Applicant: Erica Sniegowski; On behalf of St. Edwards Catholic Church
Consultant: Barr Engineering
Project: BMP Retrofit – Rainwater Gardens at St. Edwards Catholic Church
Location: 9401 Nesbitt Avenue: Bloomington
Rule(s): 3,5,10
Reviewer: BCO

**Non-Profits 2019 BMP Retrofit Projects:
 Wetland Buffer Permit Requirement - Variance Request**

St. Edwards Catholic Church
 9401 Nesbitt Ave S., Bloomington, MN

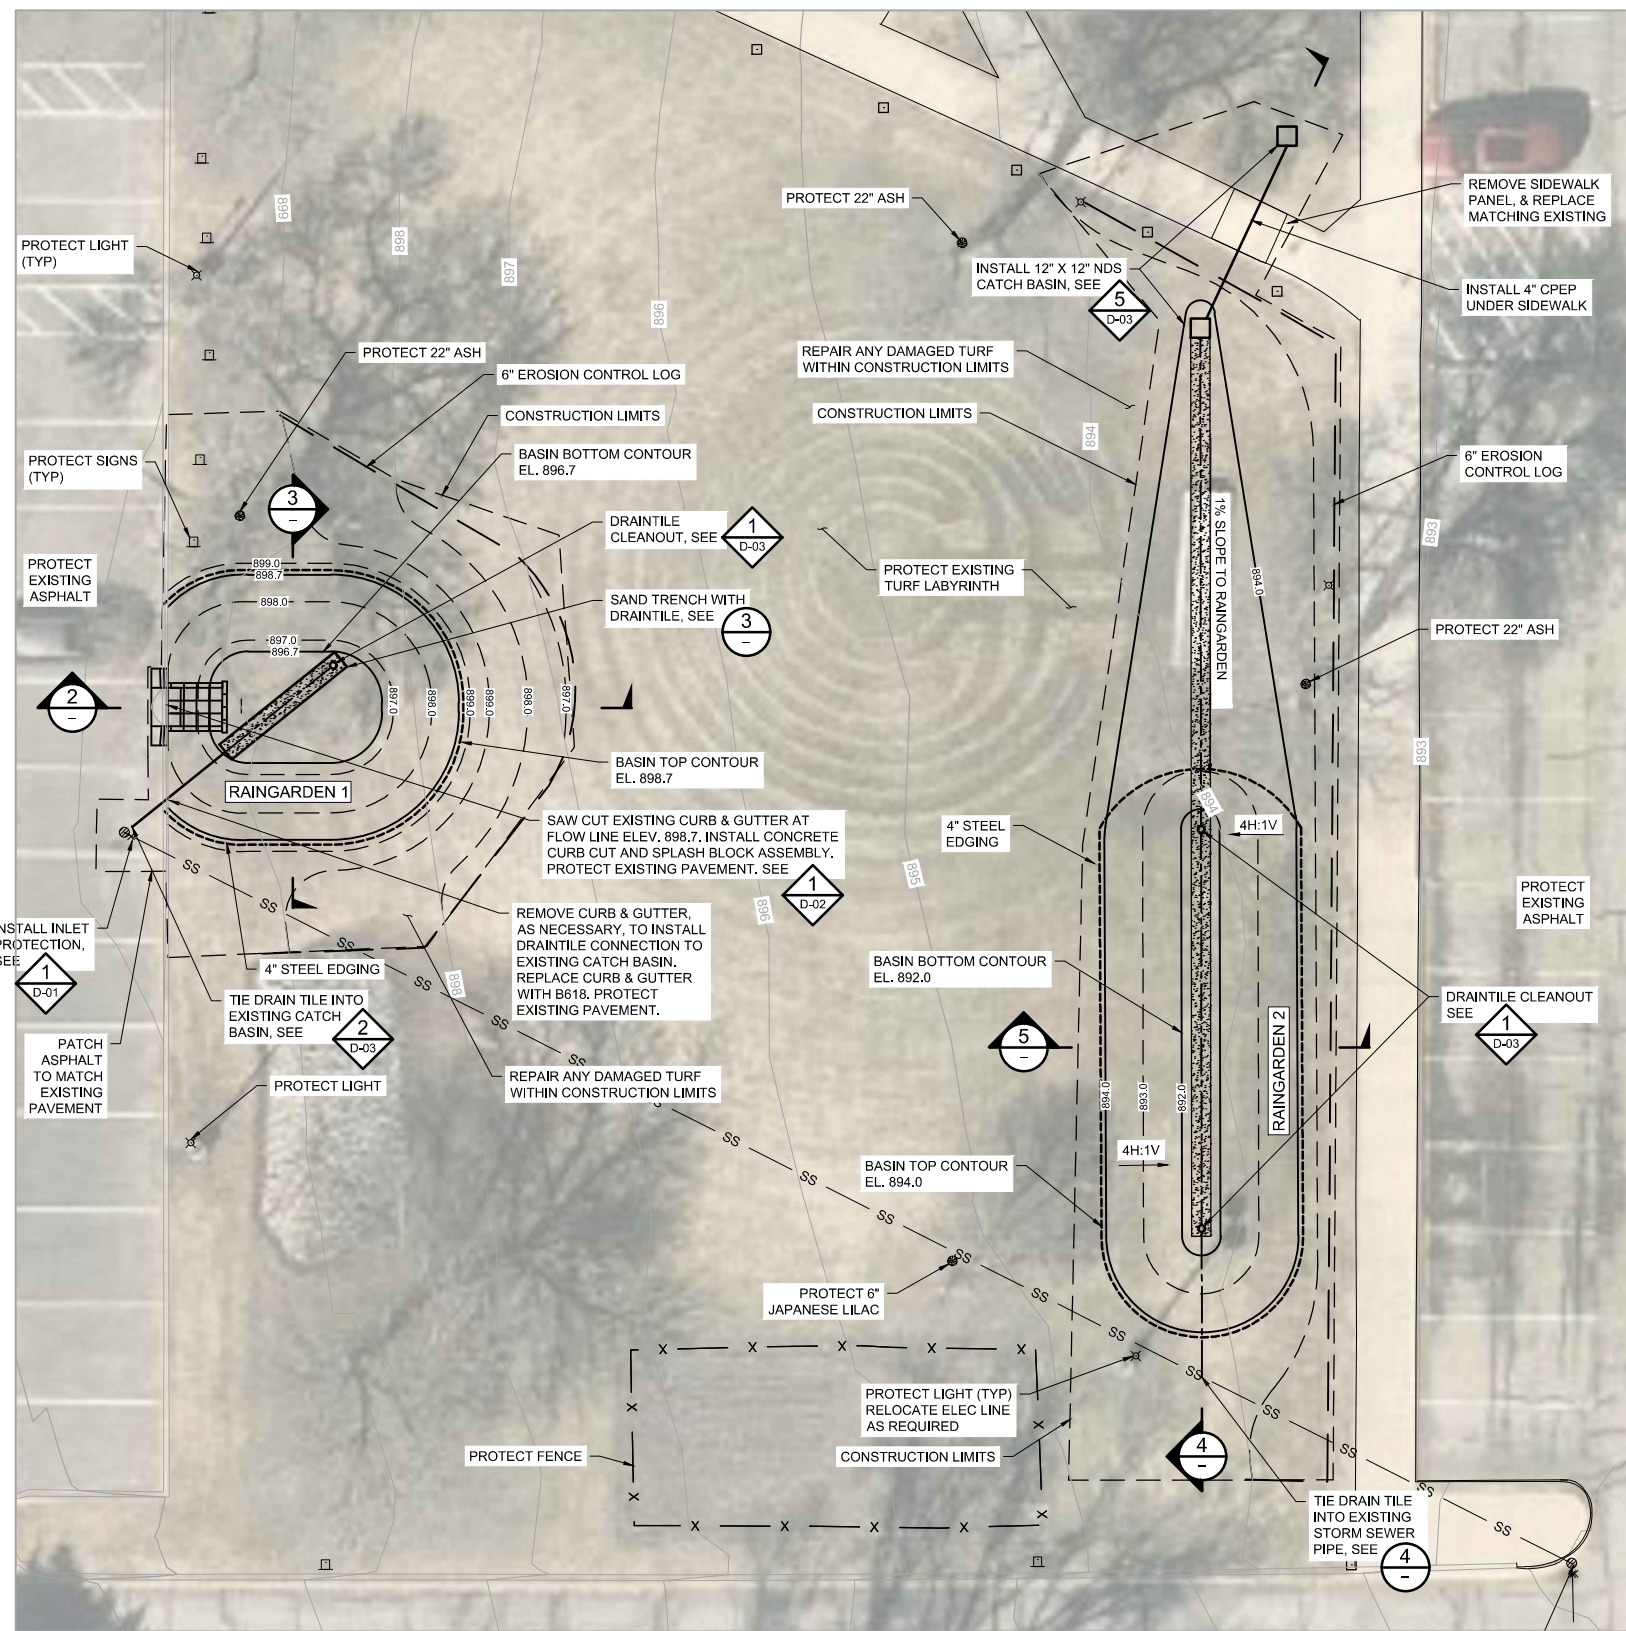
A MnRAM wetland functional assessment has been prepared and provided by the City of Bloomington for wetland 1063W. The MnRAM has determined the wetland to be a medium value wetland requiring a minimum 20 foot and 40 foot average wetland buffer. A wetland boundary determination has been completed utilizing a desktop analysis including aerial photography and Public Waters Inventory data. The existing parking lot is located within 6 feet

from the wetland boundary identified as shown on the attached figure. Because of the existing site constraints, existing surface parking, a variance from the average and minimum buffer width requirements in section 3.4 is requested.

Specifically as to the wetland buffer: The location of the existing parking lot does not allow for compliance with the 20 foot minimum or the 40 foot average (total buffer area) buffer requirement. The existing condition will not change as a result of the project. The alternative to not approving the variance would be to request the applicant remove a portion of the existing parking lot for compliance with the District's buffer requirements. With regard to the maintenance requirement, the buffer area will not be disturbed by the project activities. As-is, the area is grass with a few trees and invasive buckthorn – i.e., not high-quality vegetation, the maintenance of which serves a critical policy of NMCWD.

Wetland Buffer Calculations
20' buffer area within parcel:
 14,262 SF, which is 2,507 SF short of 20' buffer area requirements.
40' buffer area within parcel:
 18,074 SF, which is 14,099 SF short of 40' buffer area requirements.
Note: Buffer limits shown were taken from the water's edge in the wetland, not from a wetland boundary determination.

1 PLAN: GRADING, EROSION CONTROL, AND REMOVALS

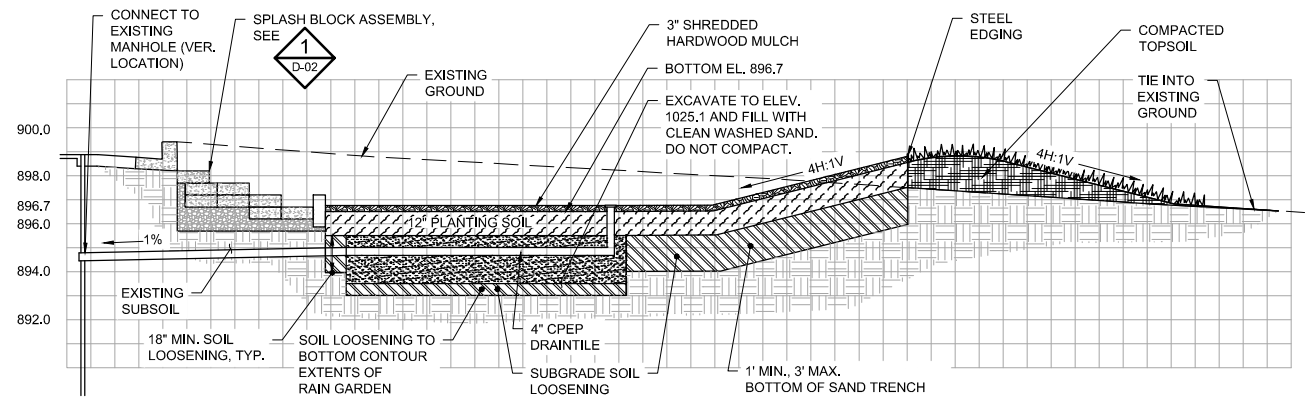
The submitted erosion and sediment control plan includes sediment control logs and inlet protection. The project contact is Erica Sniegowski, Nine Mile Creek Watershed District Program and Project Manager.
